To: The Public, Local and State Agencies, and Stakeholders for San Diego Gas and Electric's 2021 Wildfire Mitigation Plan Independent Evaluator Annual Report on Compliance

FINAL INDEPENDENT EVALUATOR ANNUAL REPORT ON COMPLIANCE

SDG&E

Independent Evaluators:

Image 6: Covered conductor issues observed.

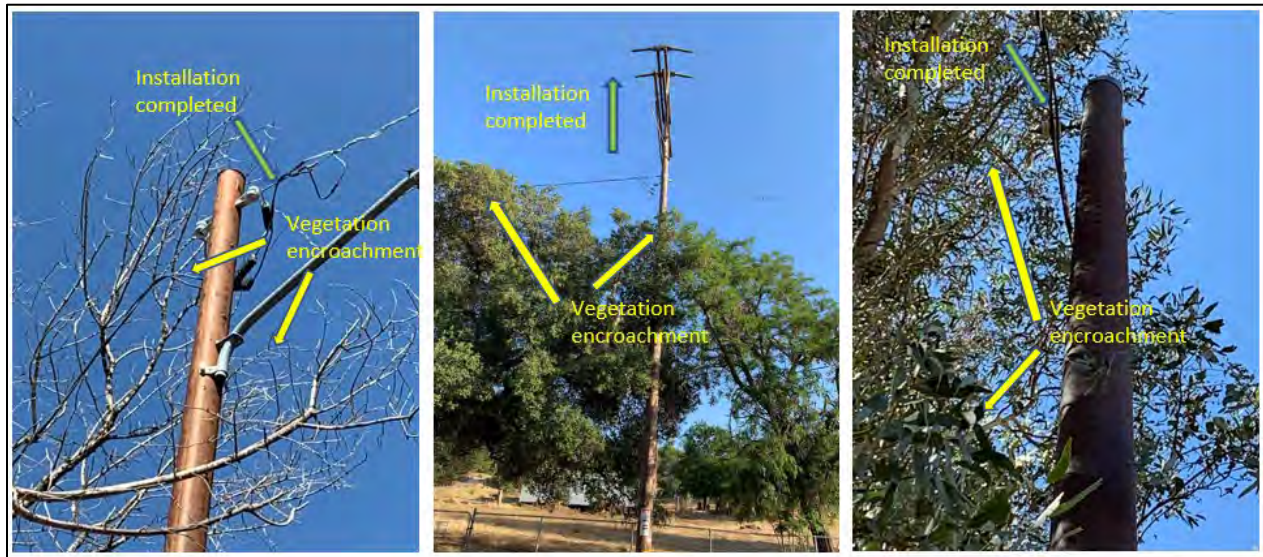
The sample is statistically applicable to the full population and provides useful feedback to SDG&E. In 55% of these installations, covered conductors were observed with no issues. In 12% of these inspections, however, issues were observed—in 9% of the inspections, no conductor was observed. In 3%, the covered conductor was not observed, and other issues were observed. Thus, 12% of the sample showed quality issues, while an additional 27% of the sample could not be accessed for inspection.

SDG&E set its target for 2021 covered conduction installations in 2021 at 448 and exceeded that target by reaching 461. Inspections showed that 39% of the time, or 173 conductors of the 448 completed, the covered conductors installed, statistically extrapolated, might either demonstrate quality issues or be inaccessible for verification. Based on the discussions and analysis above, the IE is unable to verify that SDG&E met its target for this initiative.

Image 9: Fuse-related issues.

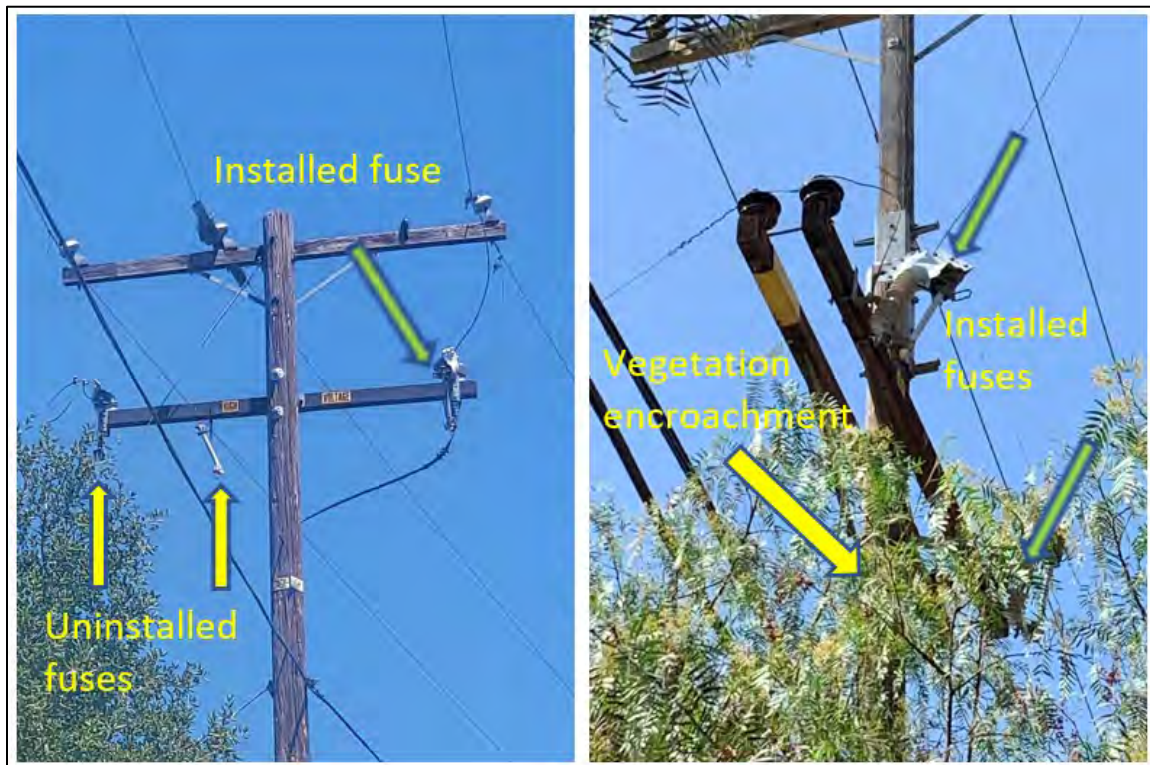
- Fuses issues observed:
 - In two sample locations fuses were not installed
 - In one sample locations fuses show signs of physical degradation
- No fuses issue observed/Other issues observed
 - In one sample location the base of the pole was eroding
 - Vegetation encroachment was observed in several sample locations. Vegetation is within 10-feet of the clearance radius around the pole.
 - In two sample locations the poles integrity show signs of physical degradation
 - Lightning arrestors show signs of physical degradation in one sample location
- Asset could not be located
 - Multiple sample locations with the same coordinates
 - No poles in place for the given coordinates on three sample locations
- Unable to access and inspect the asset
 - The assets were behind a locked gate

SDG&E met their installation target for replacement expulsion fuses, exceeding the target of 3,970 fuses by installing 3,976. The 3% fraction of the sample that showed quality issues has the effect of discounting the achieved total by 5% or 119 fuses.

Image 11: Hotline clamps findings

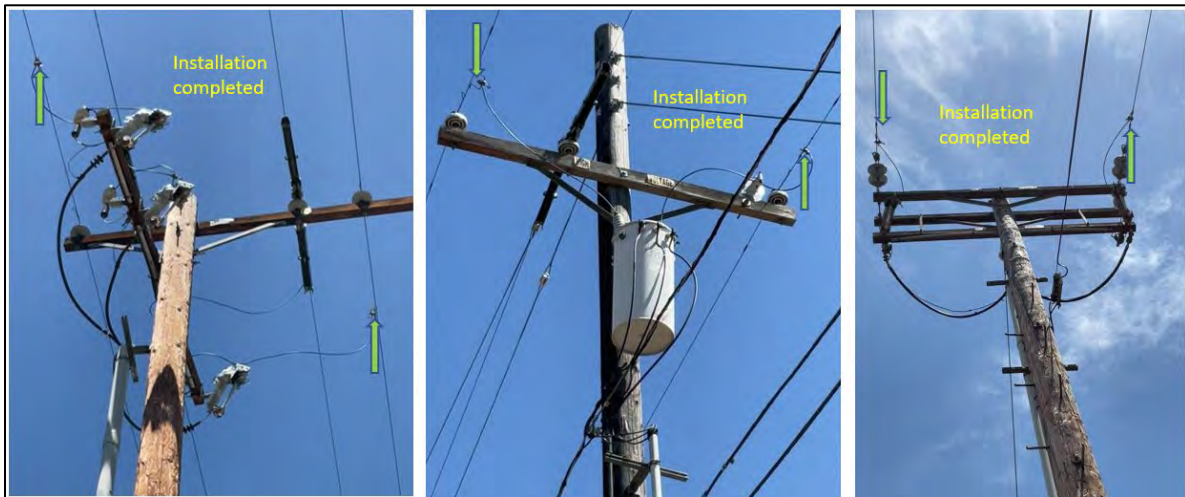
SDG&E met their 2021 installation target for hotline clamps, exceeding the target of 2,250 clamps by installing 2,743 hotline clamps for the year. In addition to the 15% of the sample that was inaccessible, the IE found 5% of the total sample to have quality issues. Together, this 20% represents 548 clamps where the IE cannot verify either the installation or its quality. The adjusted 2021 total for hotline clamps is therefore 2,195; short of SDG&E's 2021 target by 55 clamps.

Image 15: Overhead hardening verification with observations.

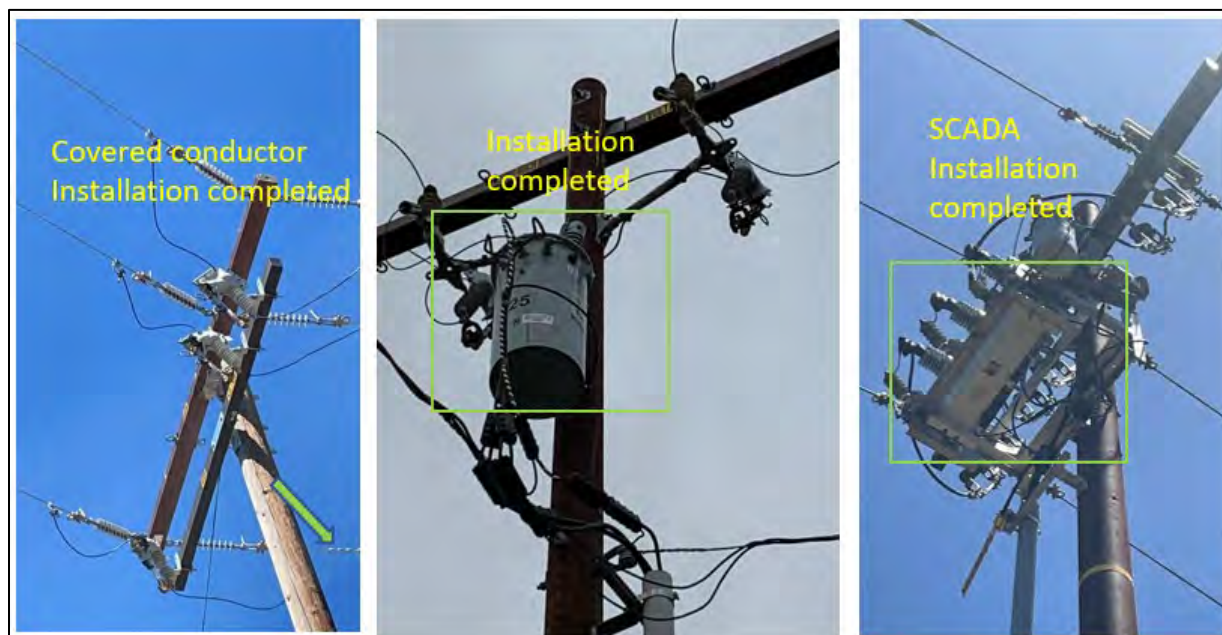
The final verification sample size of 34 is statistically valid for the final population of 2,247 poles. The fraction of the sample size with quality issues constitutes 32%, that is 11 out of 34. By extrapolating this percentage to the general population, 728 out of 2,247 poles are anticipated to have the similar quality issues, as described above. This results in an adjusted total of 1,519 poles of overhead hardening activities successfully completed in 2021.

Image 17: Powerline locations, pole locations and locations of grid hardening work.

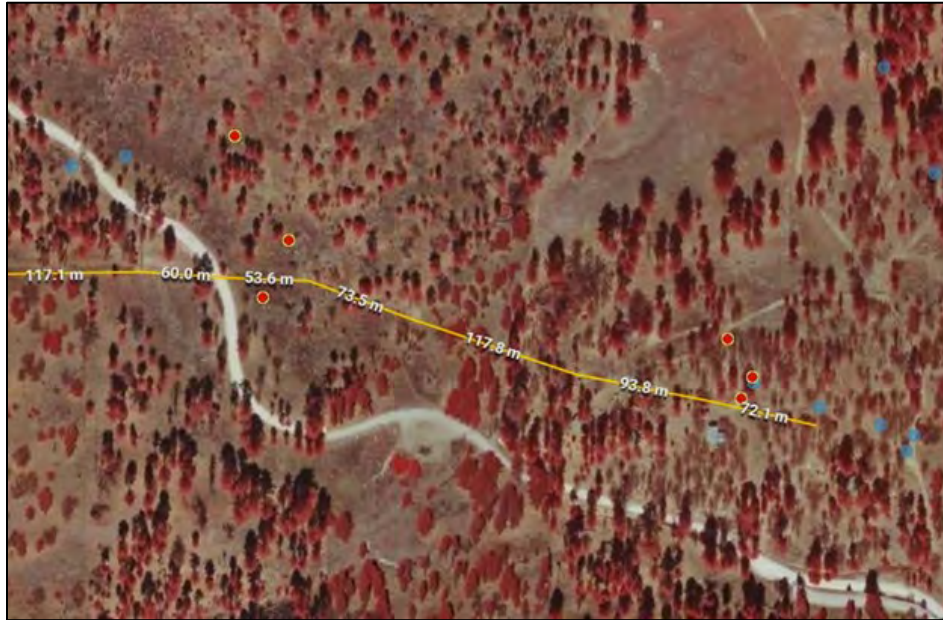
Discussion of Pole Locations – In some areas where reported work took place, it was found that points lie in areas no poles could be found. Often, the connection between poles and points could not be established, as distances between power lines and points were sometimes over 100 meters (Image 11).

In Image 17, the yellow line shows the new powerline between the locations of poles visible on images. The yellow-rimmed red points indicate poles where work has been reported as performed by SDG&E while the blue points represent poles without grid hardening work. Yellow-rimmed red points should represent locations of a poles, but IE could not verify the existence of a poles on those locations. Pole locations that do not intersect with the yellow line of the powerline itself suggest the inaccuracy of the GPS pole locations which denied IE the possibility to tie the observed poles with reported new poles.

Image 21: Issues on lightning arrestor inspections.

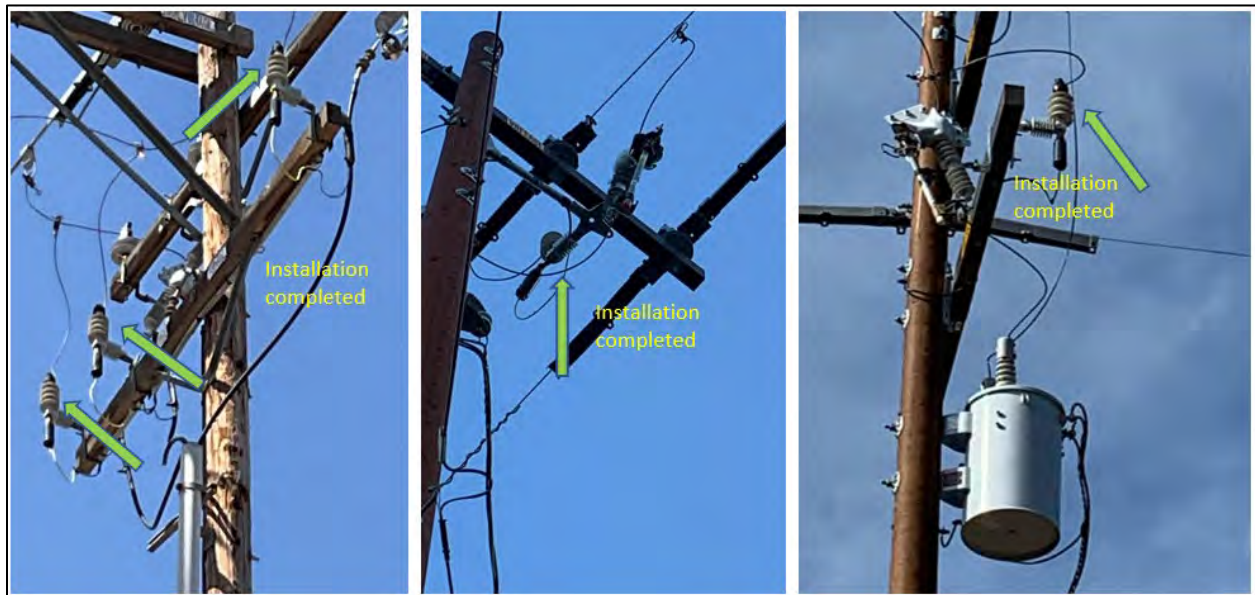
SDG&E set the target to remove and replace 1789 new lightning arrestors in 2021. By year-end, however, the effort had fallen short of its target by 865 (48%) coming in at 924 lightning arrestors replaced for the year.

Image 24: Vegetation encroachment visible in field inspections.

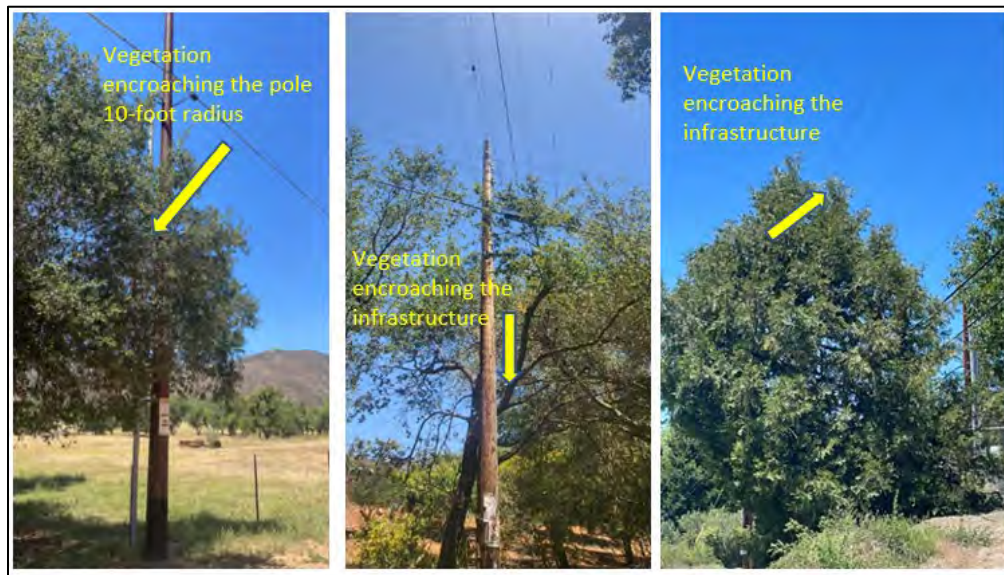
The IE’s analysis documented that 13% of the sample demonstrated unacceptable vegetation management and thereby failed to meet the required standards for this initiative. Applying that percentage to SDG&E’s reported performance of 502,132 detailed inspections around distribution lines suggests that 65,277 of the inspections in that total also did not meet the standards. Discounting the reported total by the unacceptable fraction leaves SDG&E with 436,855 detailed inspections that met the required standards. This total falls short of the 455,000 2021 target. Despite all internal audits on subcontractor’s quality of vegetation management work, the IE finds substandard subcontractor’s performance, including trimming crews, arborists, and even auditors.

Image 31: Vegetation encroachment observed.

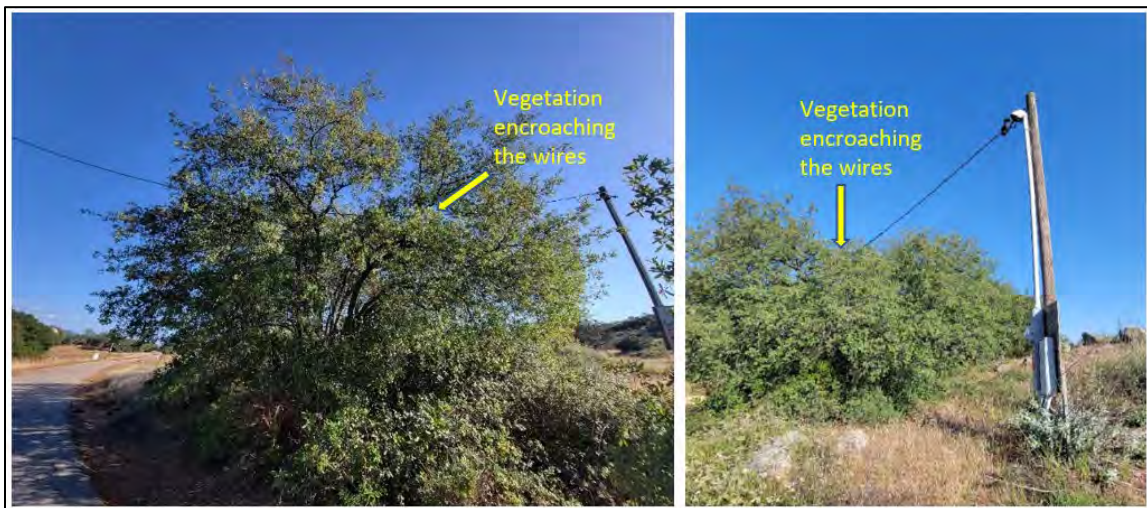
The IE’s analysis revealed that discretionary inspections frequently occur on private property, falling “beyond inspections mandated by rules and regulations.” While the resulting sample is too small to be statistically valid, the information gleaned suggested that the majority of discretionary inspections meet high standards of quality. However, based on SDG&E’s reported outcomes, which were shy of their target by over 400 trees, the IE verifies that that SDG&E did not their objective for this initiative.

Image 32: Findings for Initiative 7.3.5.20 Pole Brushing.

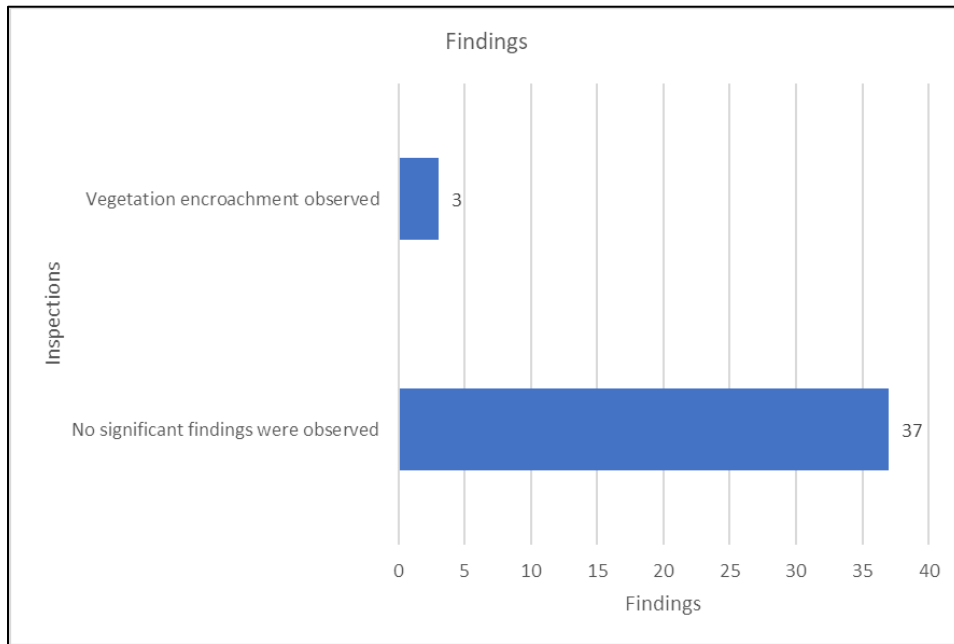
In 33% of the sample locations, pole brushing was completed without issues according to the clearance protocols. The IE defines this as no vegetation growing at the base of the pole nor any vegetation encroachment discovered on the asset within a 10-foot radius from the pole and 8 feet above the ground.

Image 45: Sectionalizing Enhancements with issues.

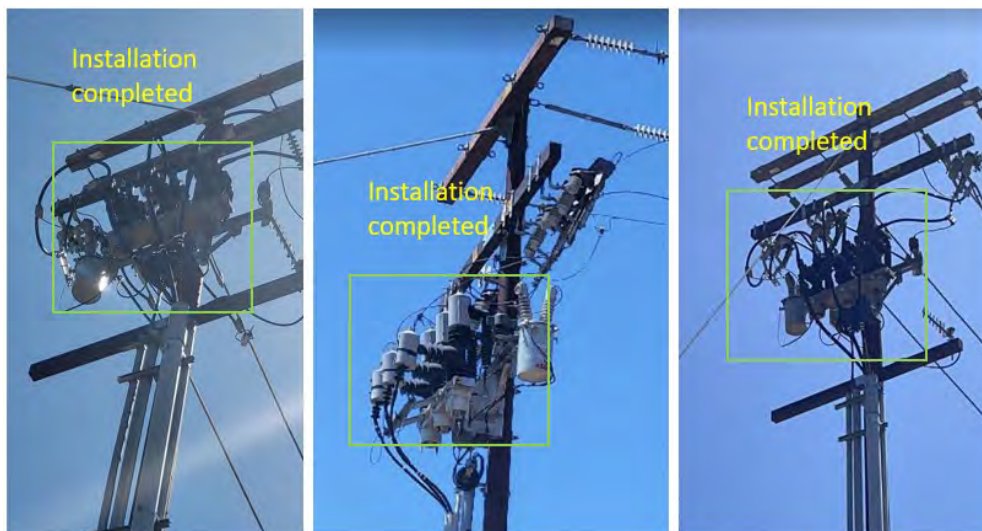
SDG&E exceeded their 2021 installation target for P5PS sectionalizing enhancements by installing 13 units rather than the ten planned. Based on the small population of units installed in 2021, a statistically valid sample consists of 9 inspections. The IE completed a total of 10 inspections.

Image 1. Location of sampled points

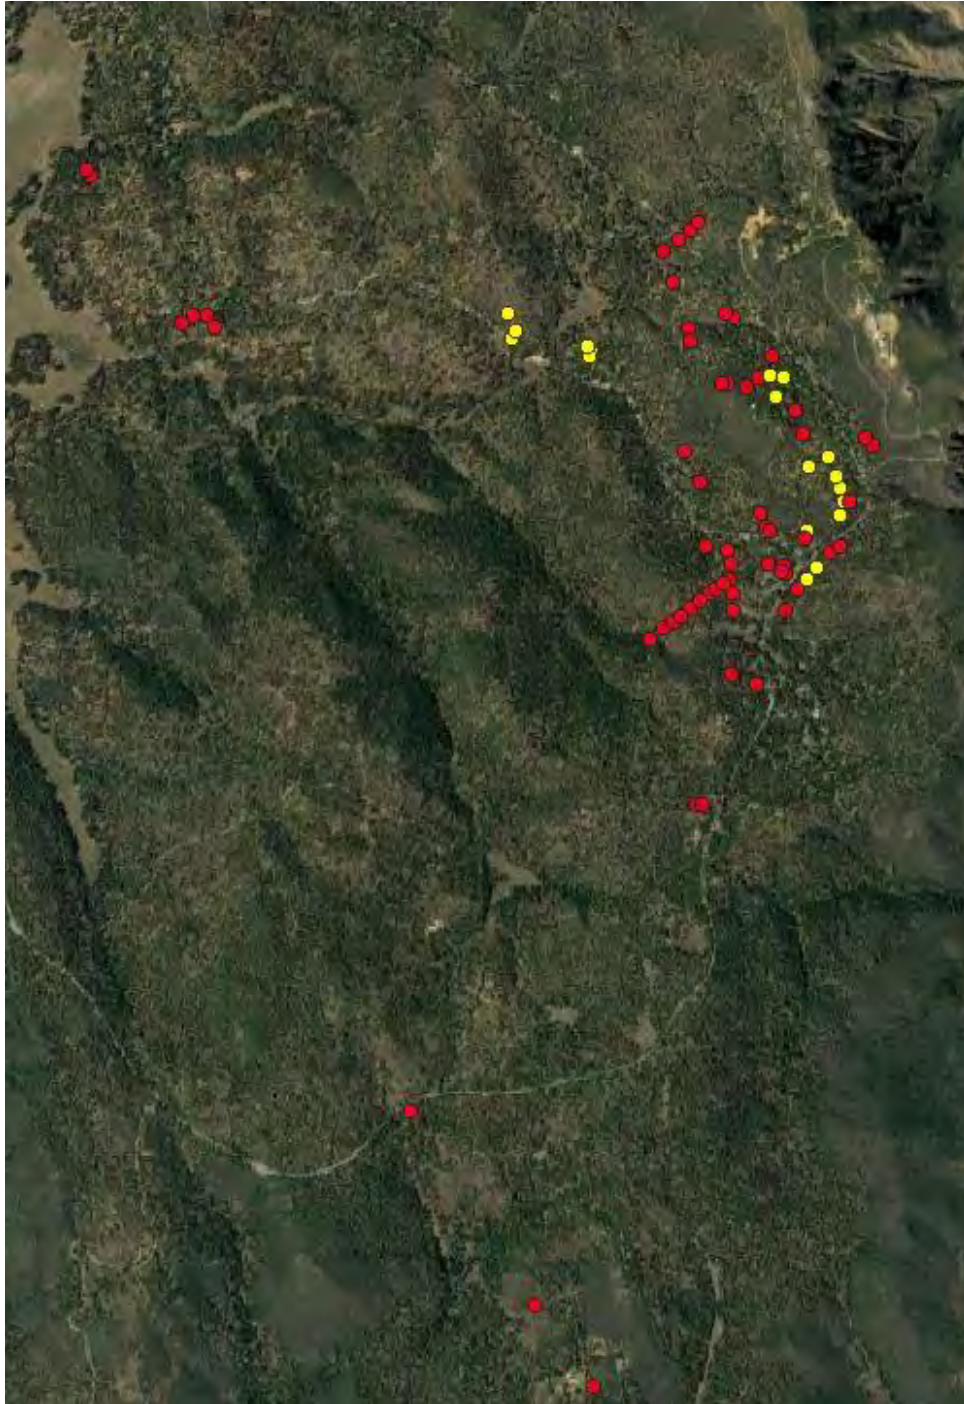
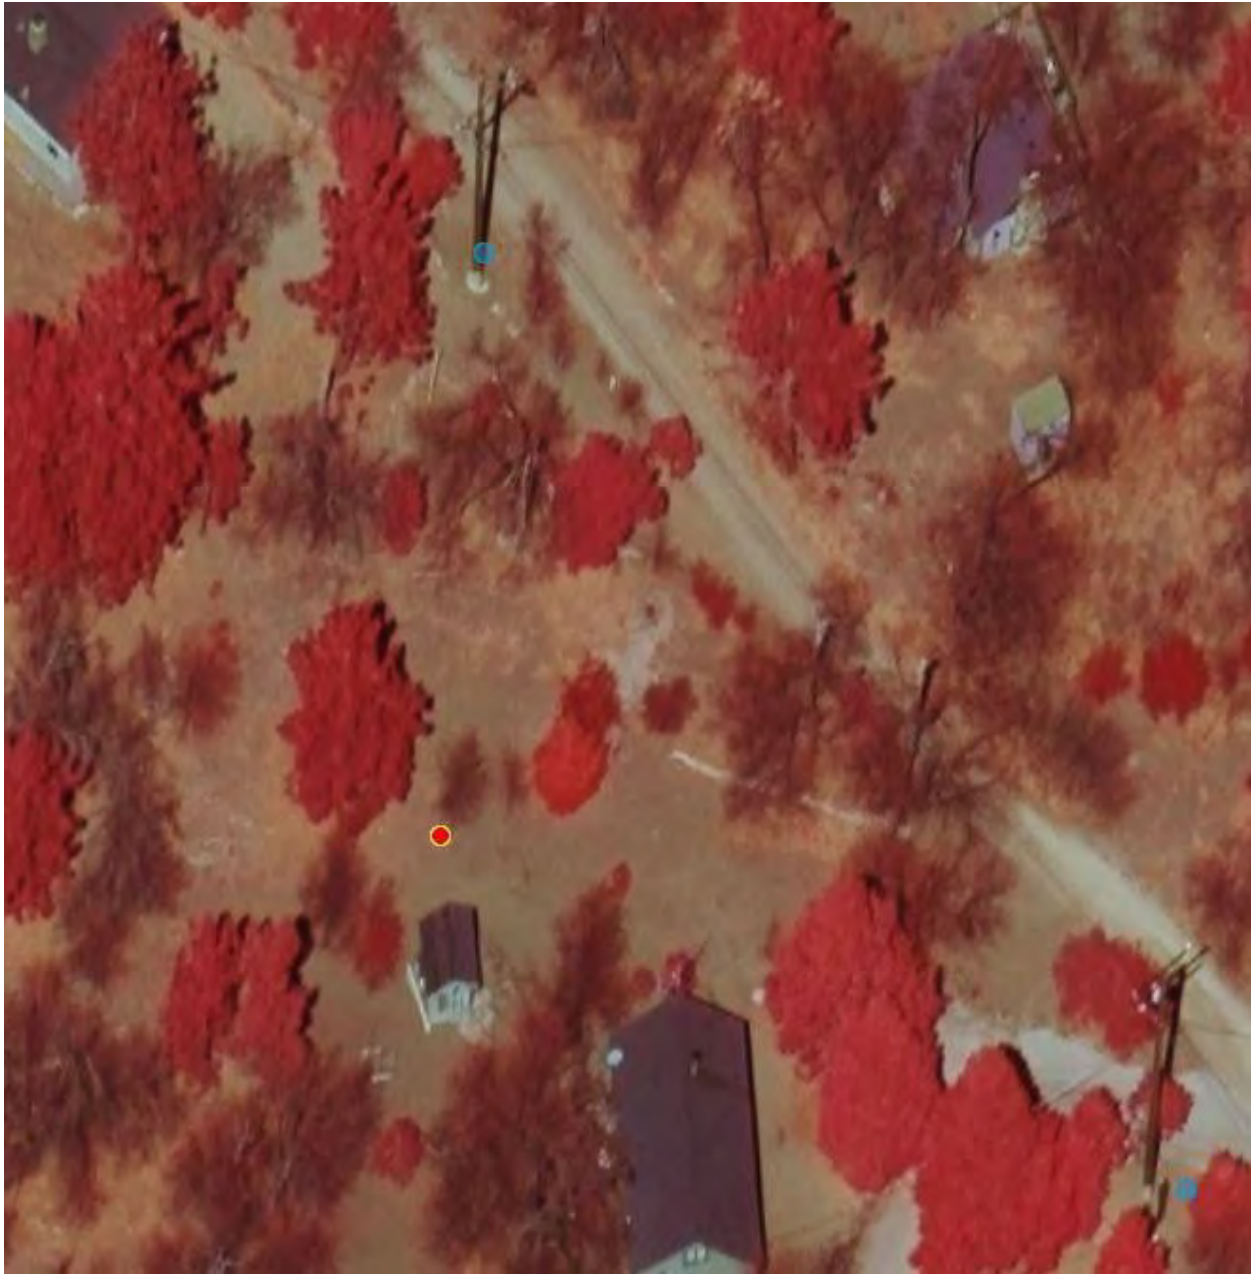
Three (3) poles, P40427, P40429, and P40363 which were tested for precision showed a very high mismatch between the position of the presented work and the position of the actual poles. In Image 2 red diamonds are positions of work reported in DR15, while purple diamonds represent the actual position of poles. Both GPS locations were provided by SDG&E. This level of error in a forested area could potentially mean loss of time and inaccuracy of fieldwork. Images 3 and 4 show poles P40427 and P40429 in CIR taken in spring 2022. In image 3 pole P40427 is presented by a lower blue dot, while the red dot placed among high vegetation should present the location of P40363. The upper blue dot in image 3 represents pole P40426.
